# Access Compliance Report

## Public Rights-of-Way

Intersection ID: 28846	Main Street: BRENLY_CT	Cross Street: FAIRCHASE_AV	Location: NW
ADA ID: 27F69A57810D	Ramp Type: PerpDiag	Initial Pass/Fail: Pass	Overall Compliance: No
		Severity Score: 17.5

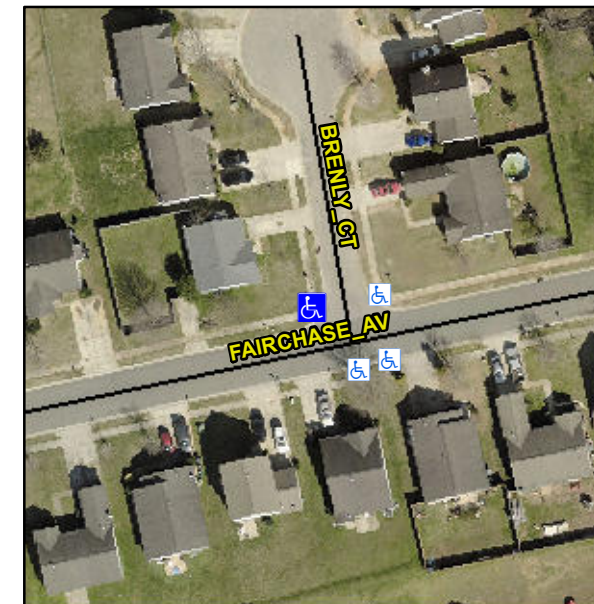
**Not Found, R305, R302.7.2**

**Remove & Replace Curb Ramp With Two New Directional Ramps or Equivalent.**
